CONTRACT 58  
NEW TRAFFIC SIGNALS  
HYDE AND VALLEJO STREETS  
TRAFFIC SIGNAL WORK AND  
POLE & EQUIPMENT SCHEDULE

SPECIFICATION NO. 1387J  
DRAWING NO. E-6.0  
FILE NO. 87,623  
REV. NO. 2

CONTRACT 58  
NEW TRAFFIC SIGNALS  
HYDE AND VALLEJO STREETS  
CONDUIT & WIRING SCHEDULE

SPECIFICATION NO.	1387J
DRAWING NO.	E-6.1
FILE NO.	87,624
REV. NO.	1

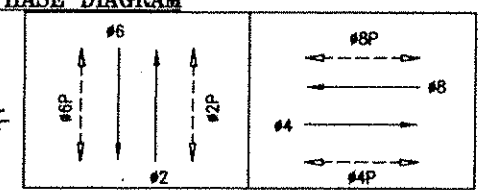
TABLE OF REVISIONS		CHECK WITH TRACING TO SEE IF YOU HAVE LATEST REVISION	
NO.	DATE	DESCRIPTION	BY
1	10/10/08	POD #4: CONDUIT & PULL BOX FOR MUNI RE-EMPTION	JS
2	6/20/08	POD #1: VARIOUS CHANGES BASED ON POLE LAYOUT	JC
